## Access Compliance Report Public Rights-of-Way (Curb Ramps)

Intersection ID: 14555 Main Street: E\_PARK\_AV Cross Street: PARK\_RD Location: SE

ADA ID: 2B0AAC0D6634 Ramp Type: BlendTrans2 Initial Pass/Fail: Fail Overall Compliance: No Severity Score: 1.25

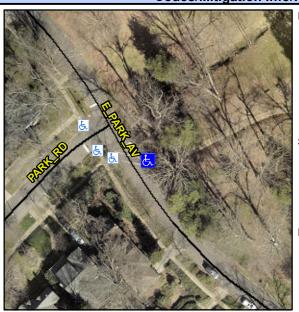
Remove & Replace Curb Ramp With
Two New Directional Ramps or
Equivalent.
